Request 13

Furnish Ford's assessment of the following vehicle conditions, including:

Figure 3: Hydroboost System Components – 2021 – 2022MY E-Series Cutaway

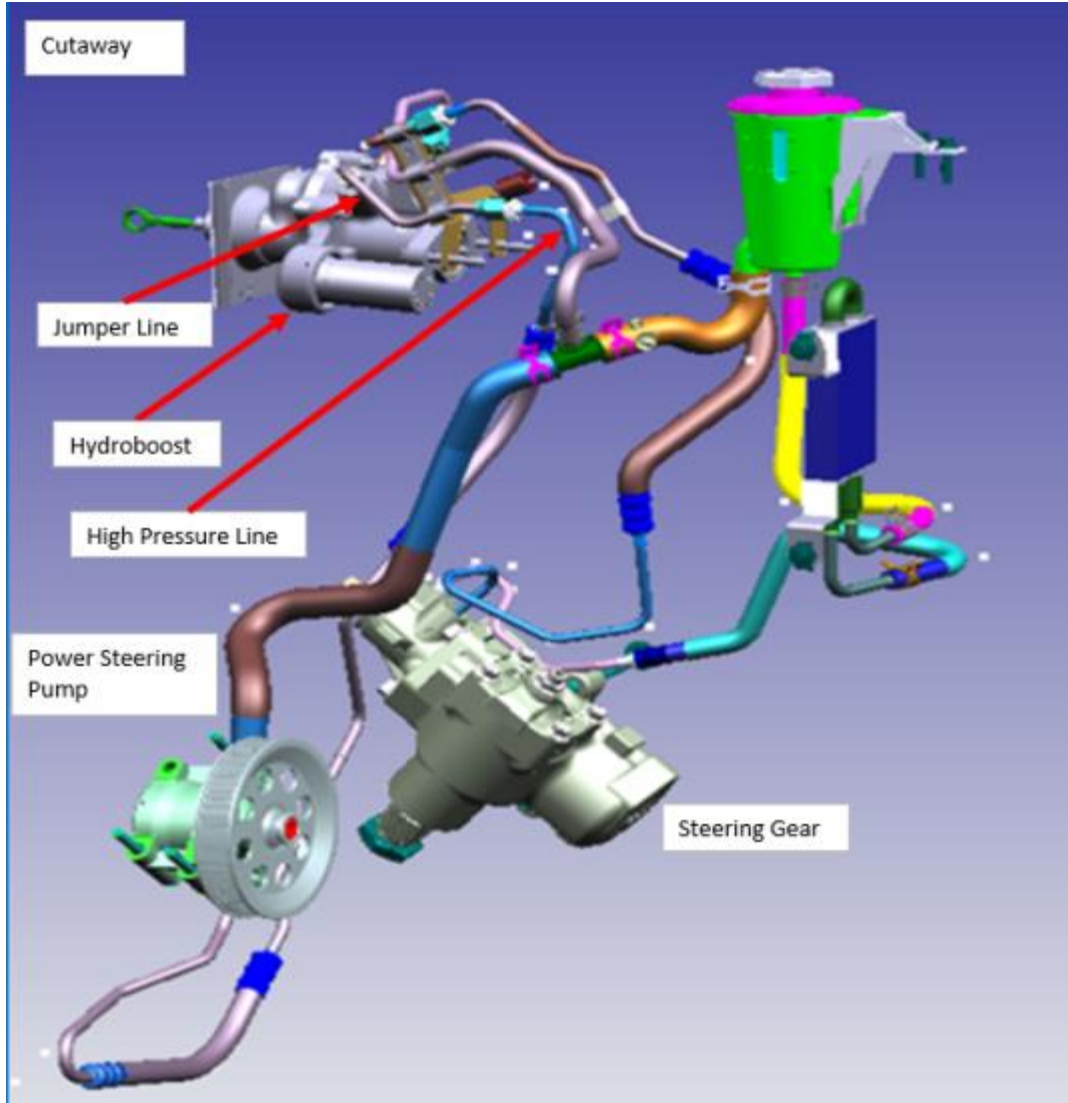
- a. Provide detail related to differences in vehicle drive options and their effect on failure conditions (two wheel drive vs four wheel drive);
- b. Provide component details, and production dates, if subject vehicles available with more than one option for the following components;
  - i. Power steering pump
  - ii. Steering gear
  - iii. Hydroboost unit
- c. Provide pressure relief detail of the power steering pump;
- d. Provide the amount of brake boost gain in relation to operator pedal application.

Ford does not believe that the type of vehicle, stripped chassis or cutaway, has an effect on failure conditions related to the alleged defect. Both vehicle types use a high-pressure power steering line and a jumper line to enable power steering fluid to flow from the power steering pump to the power brake assist booster. The high-pressure power steering line is unique between the stripped chassis and cutaway vehicle type. However, the jumper line and quick-connect fitting used to connect the jumper line and the high-pressure power steering line is common between the vehicle types.
